## Joyful View Subdivision Final Drainage Report

December 2023

HR Green Project No: 2202179

PCD File No. SF2231

**Basin ID: POND A**

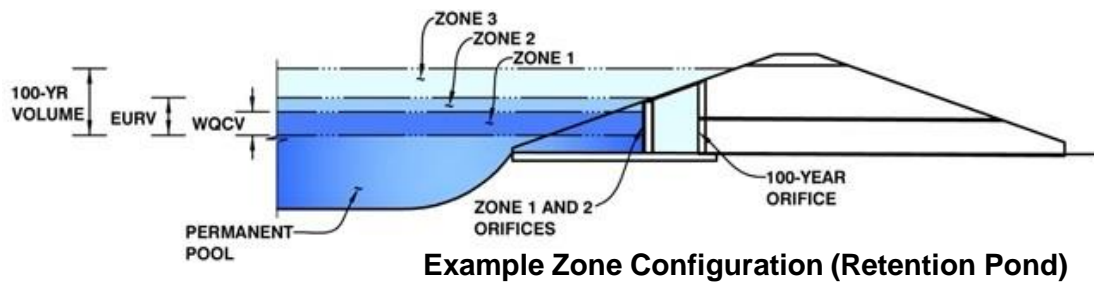
Please revise. Stage=0ft should be at 6249.50, which is the media surface elev shown on the CDs
